**FINAL DRAINAGE REPORT
FOR
STERLING RANCH RECYCLING FACILITY**

**August 2023
Project No. 25188.14
PCD Filing No: PPR-23-XXX**

PPR2341 & SF2325

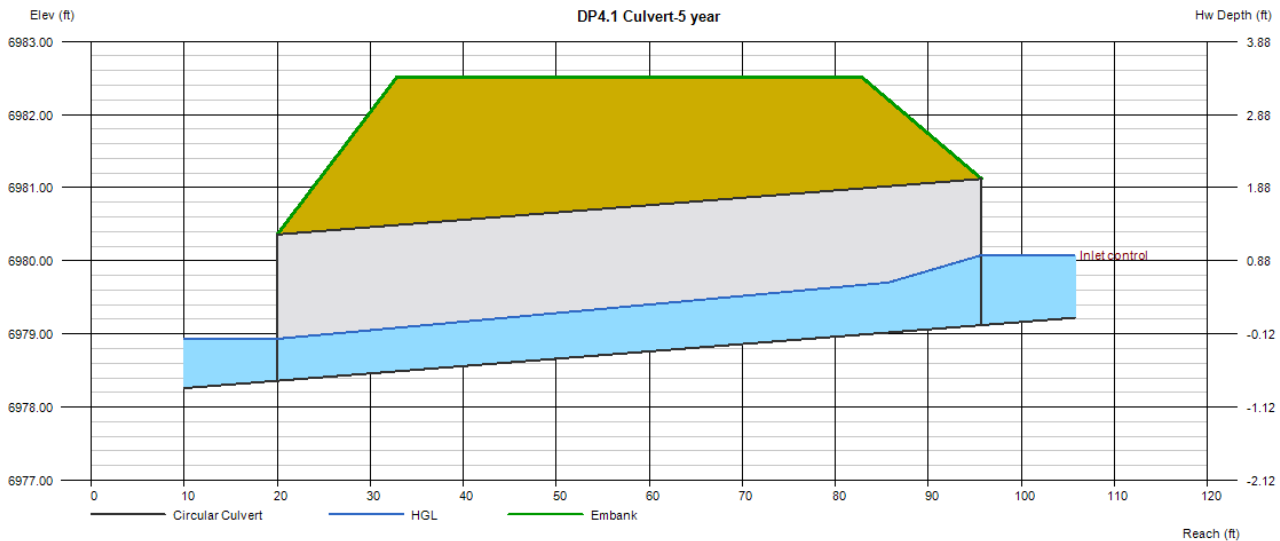
Provide calculations for riprap outlet protection

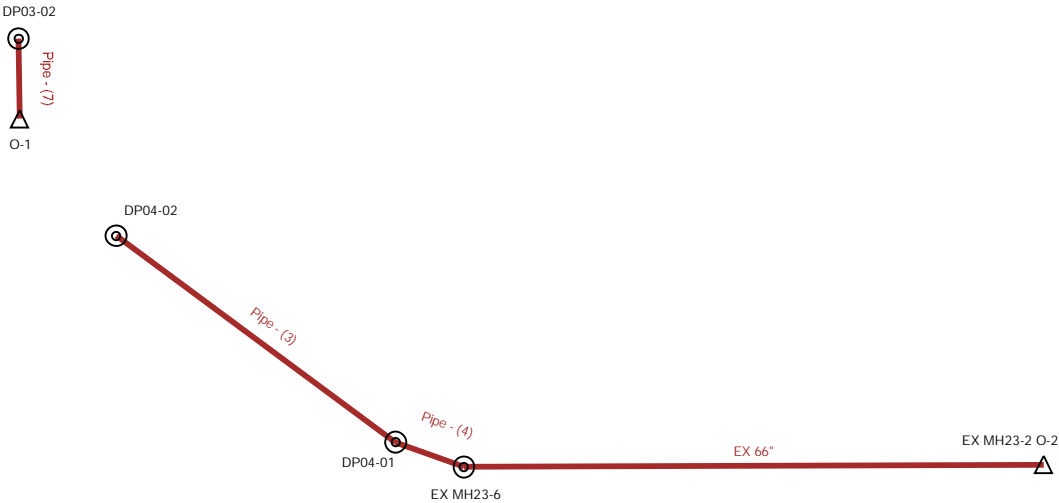
100-yr undetained flow from development is 50 cfs and flow in existing 54" RCP is 233 cfs. System needs to be able to handle 283 cfs.

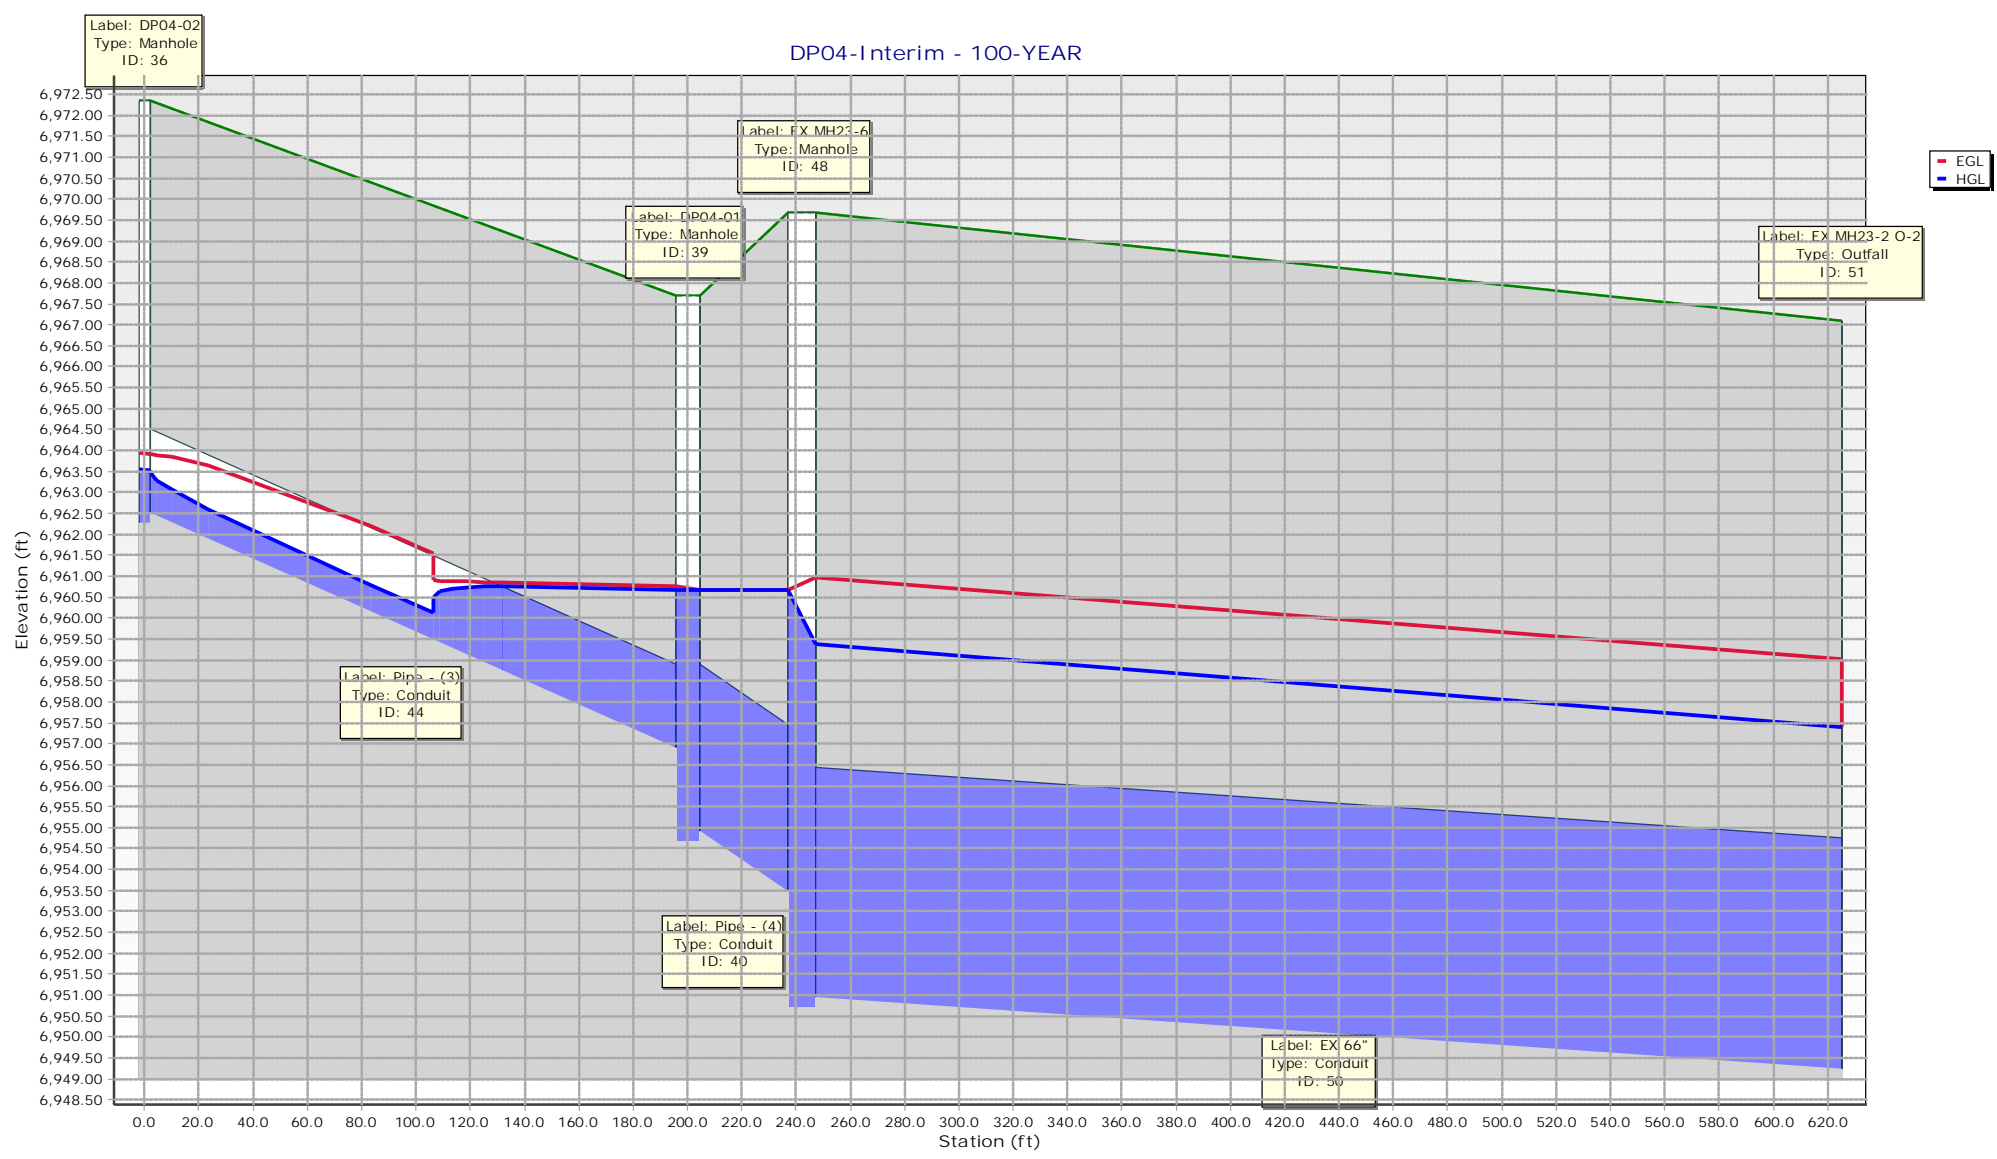
Per DCM Section 6.3.3 minimum velocity for storm sewer is 2.5 fps

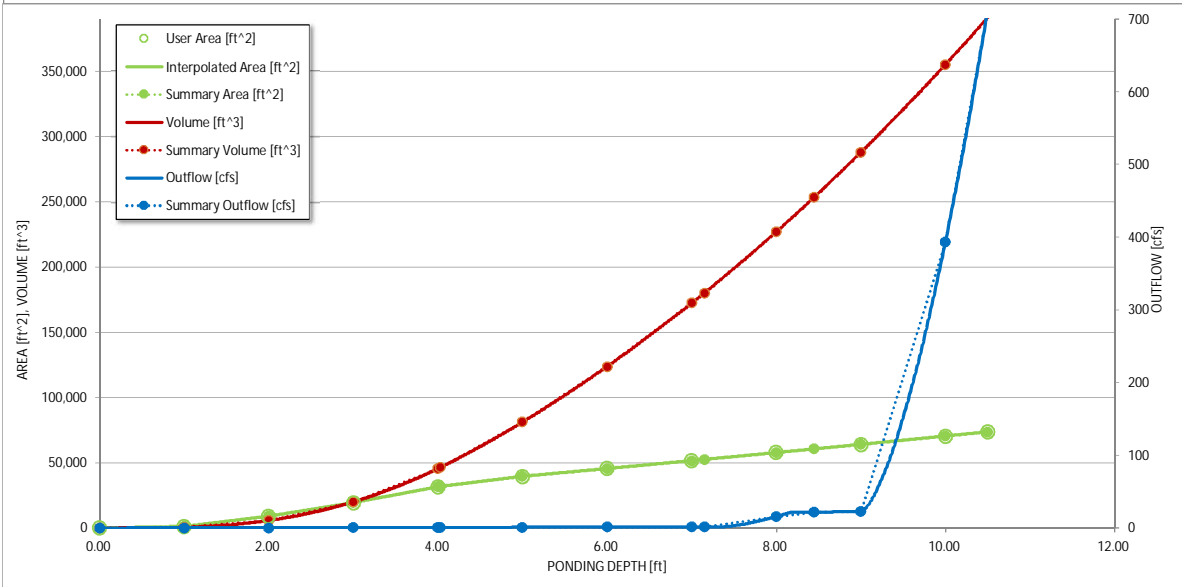
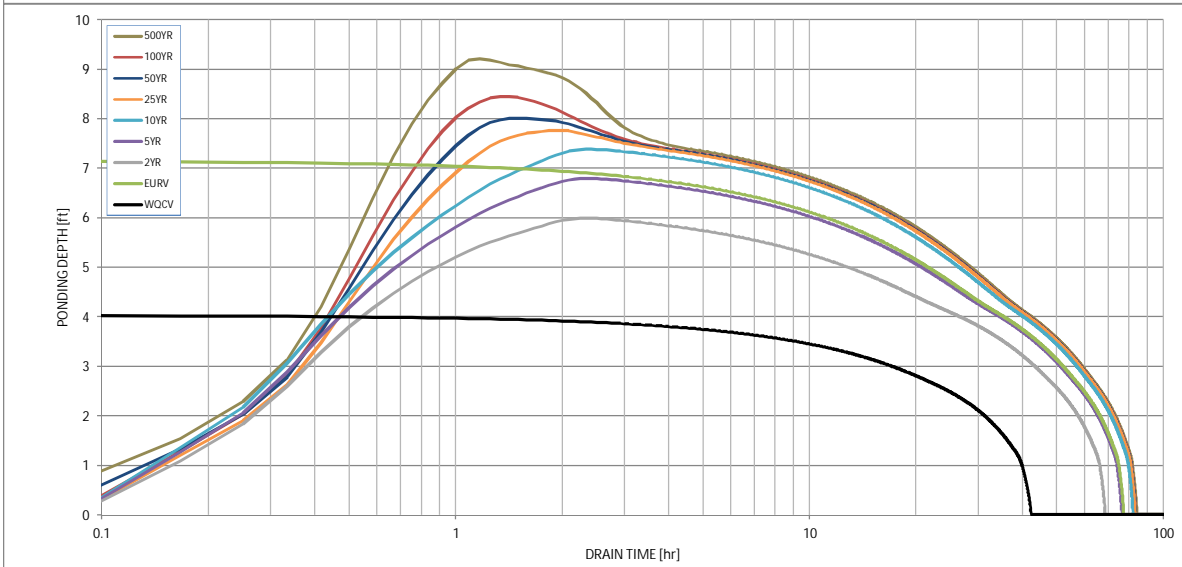
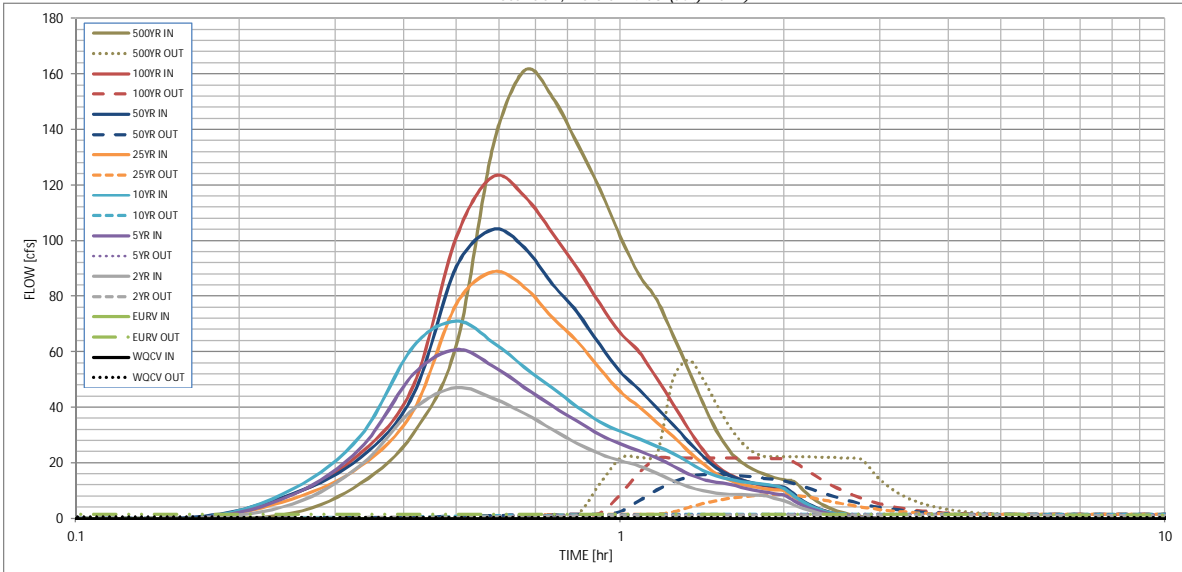
Ratio needs to be nearer to 1.0

See my comment on PDF pg 12 above about these exceedances.

Per Basin sheet, required 100-year volume is 6.00 ac-ft

EMERGENCY SPILLWAY SECTION AND SPILLWAY CHANNEL

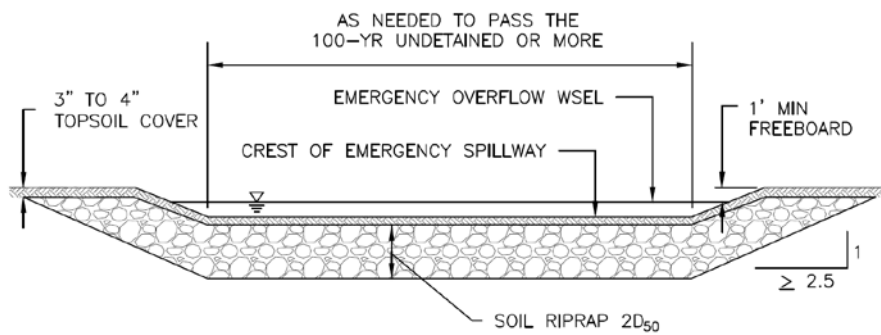
Will spillway have a cutoff wall? If not, cross off this text to avoid confusion or add a note on this page explaining that a cutoff wall will not be used.

EXISTING DRAINAGE MAP

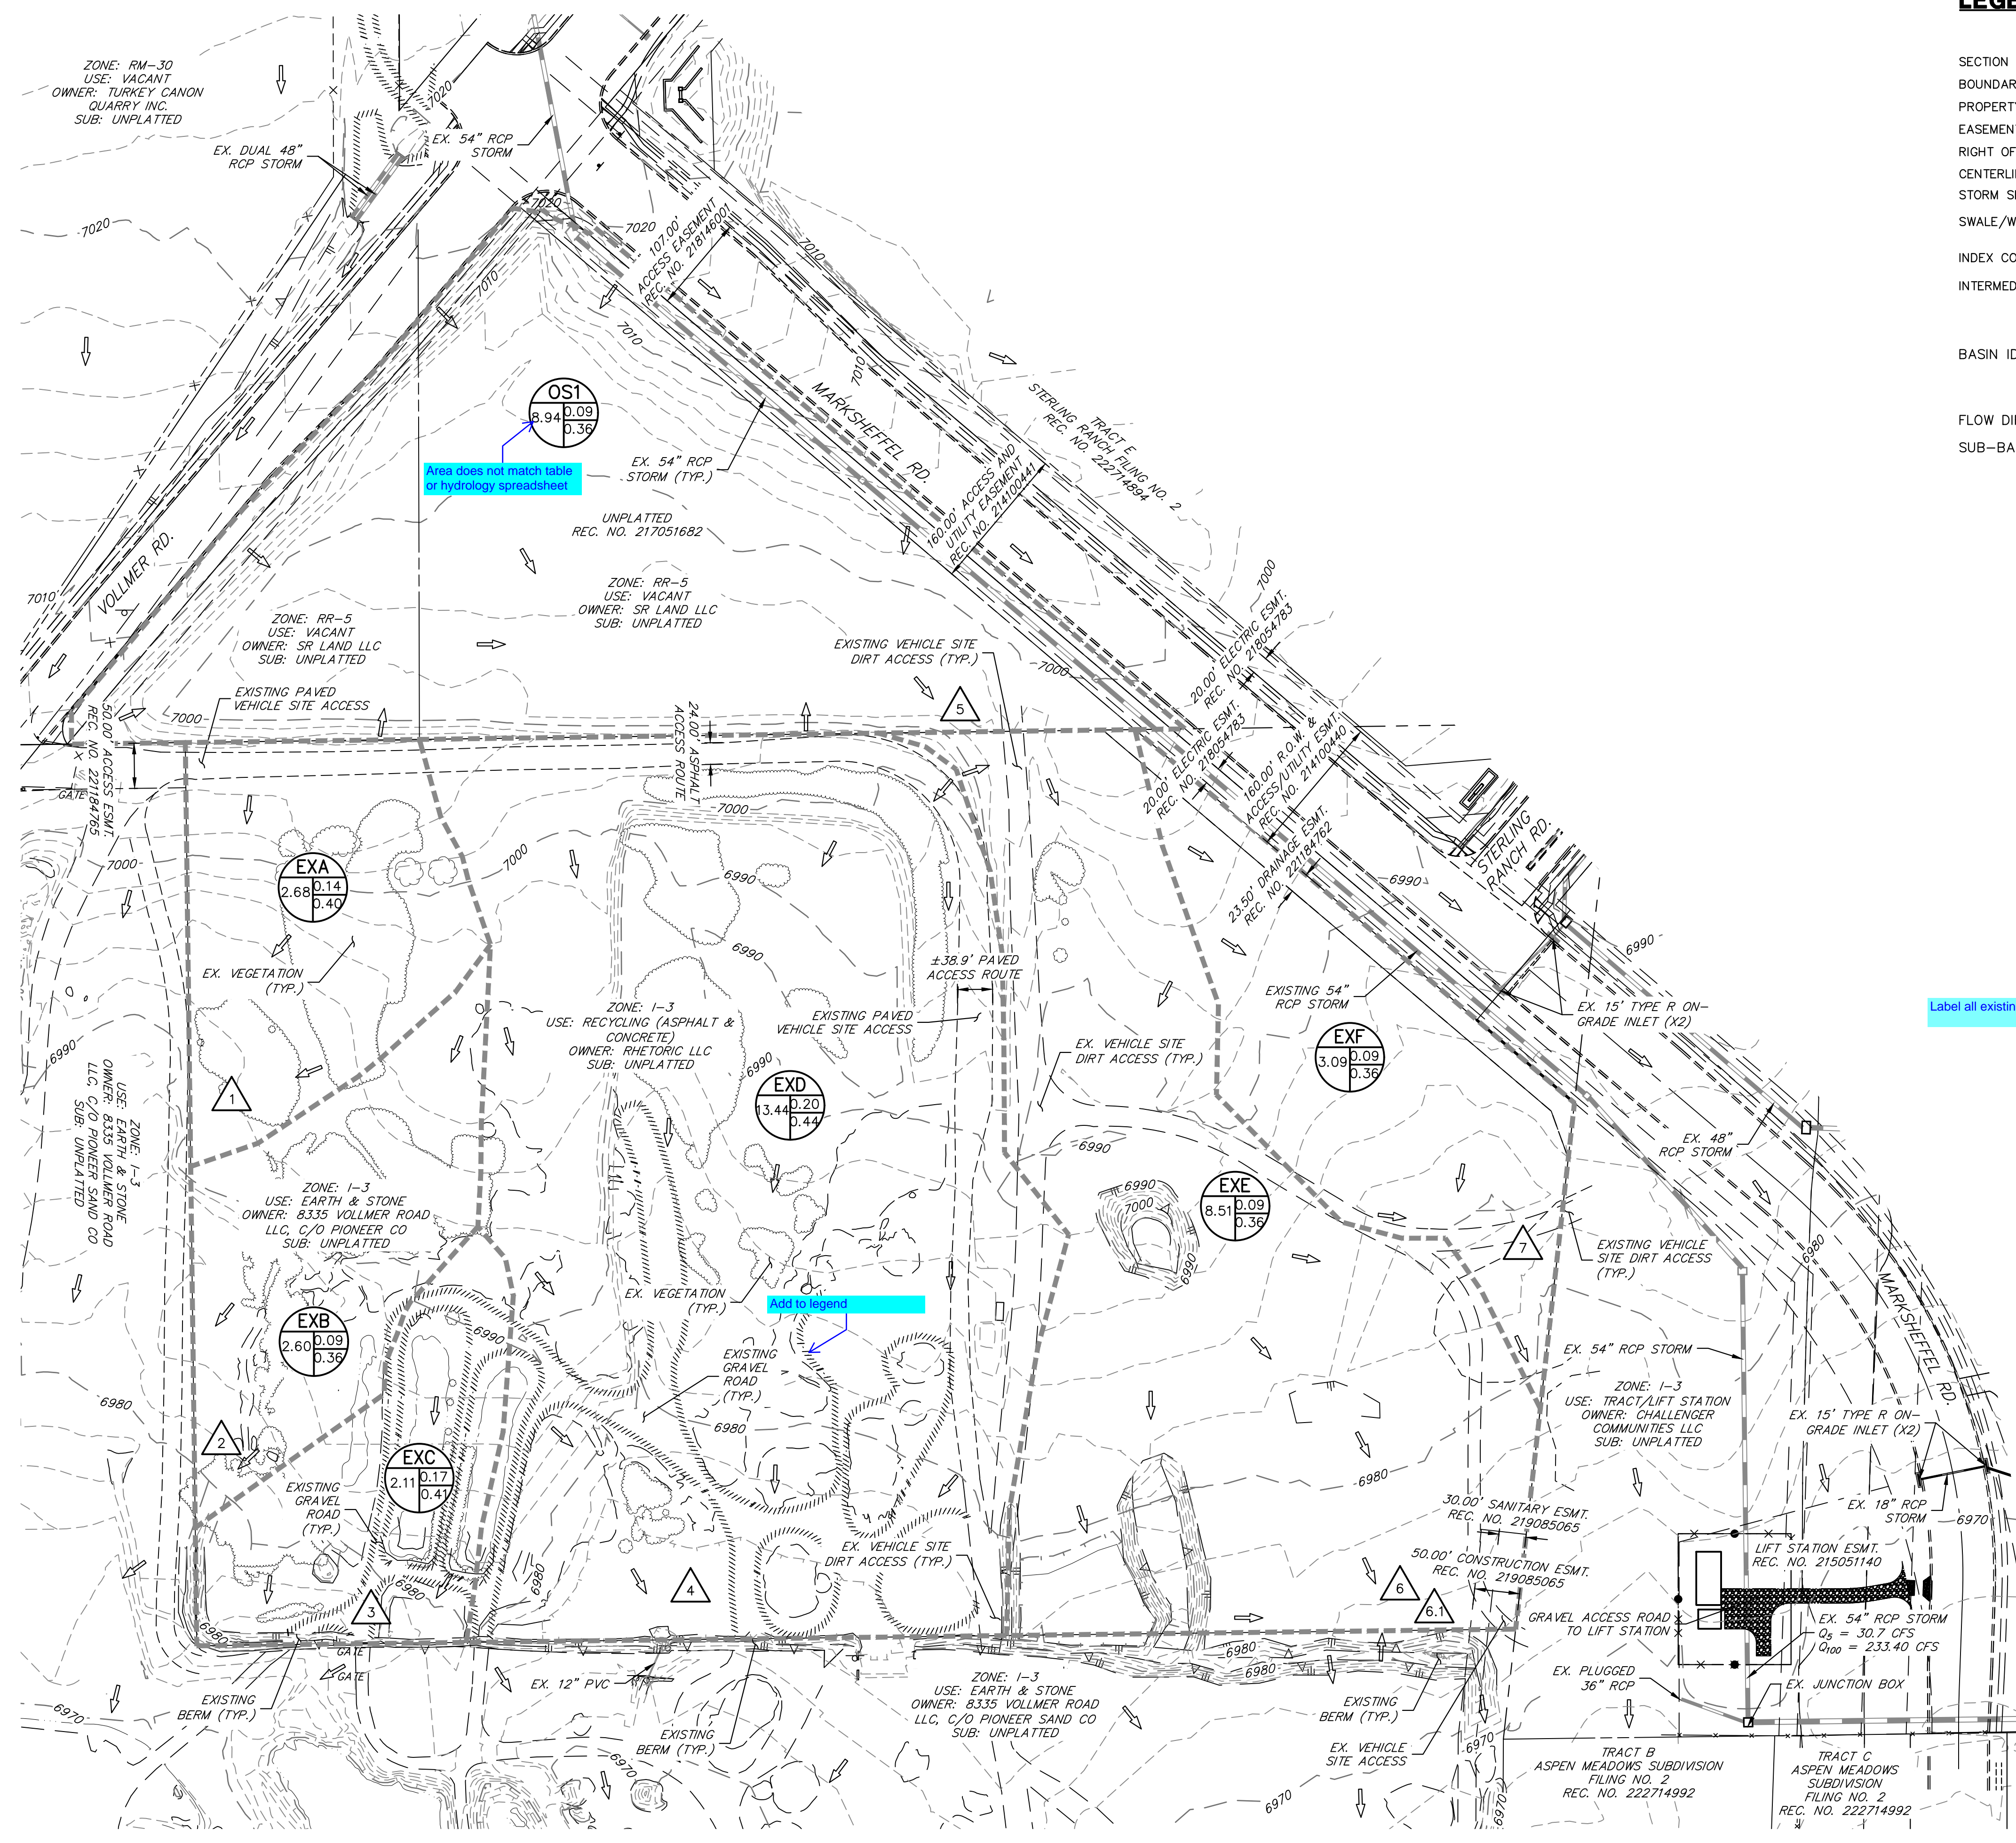
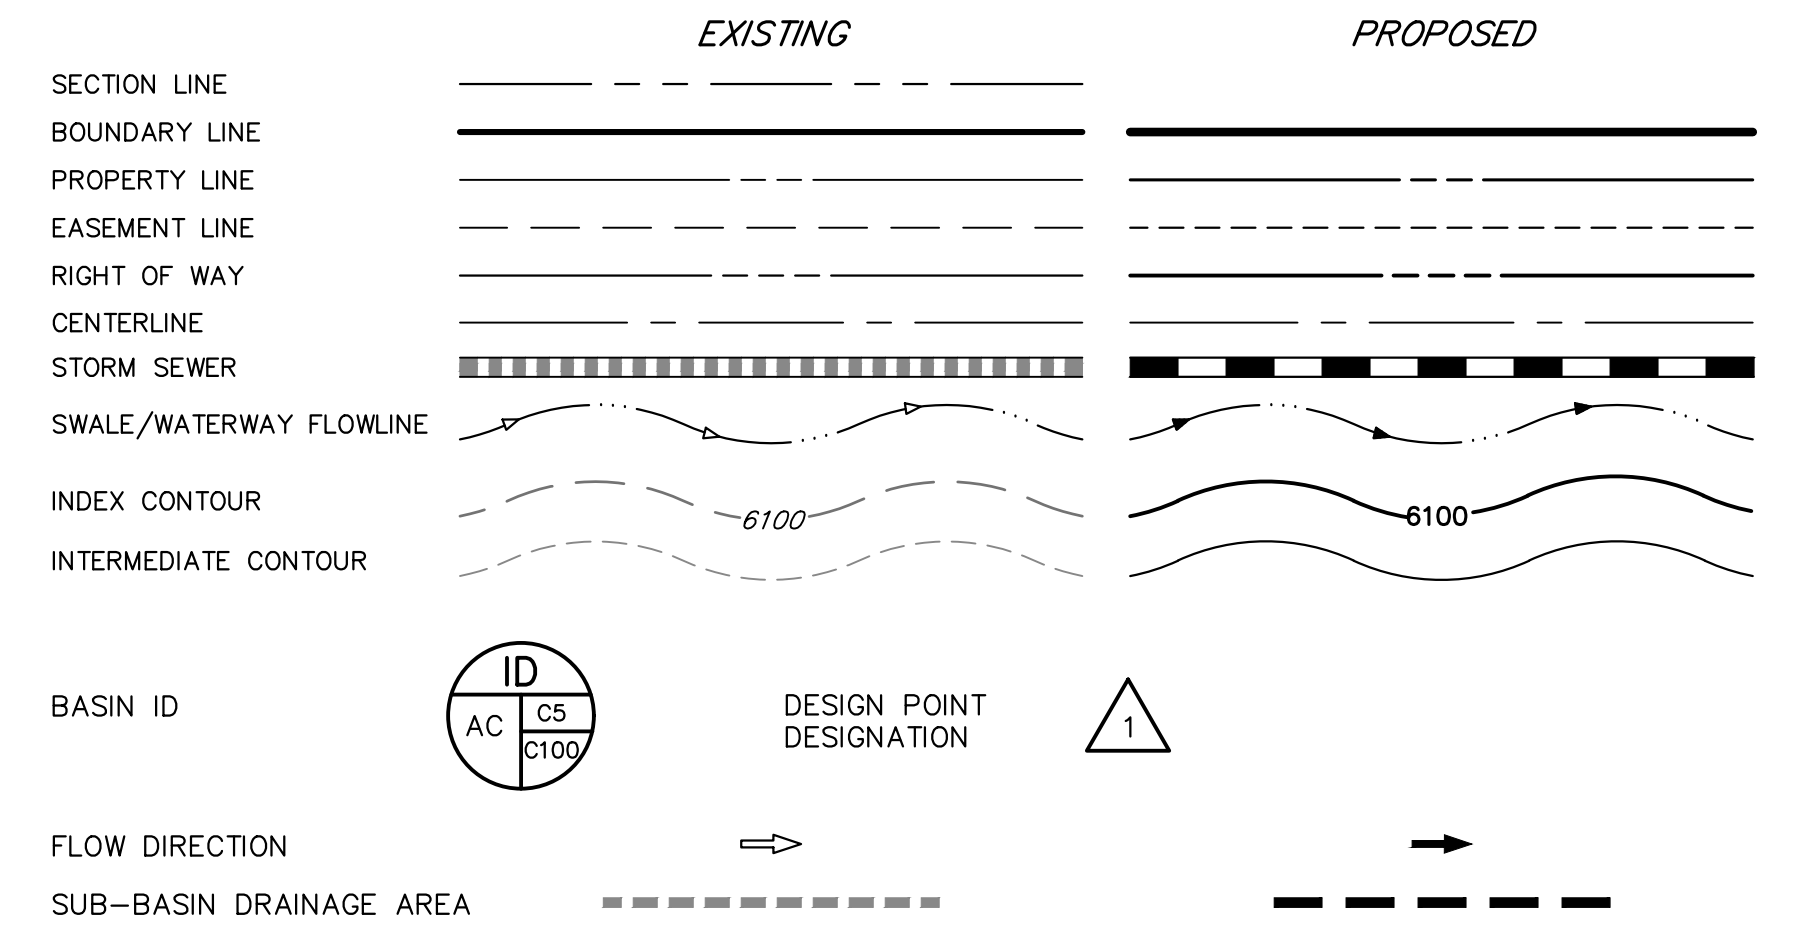
Add to legend
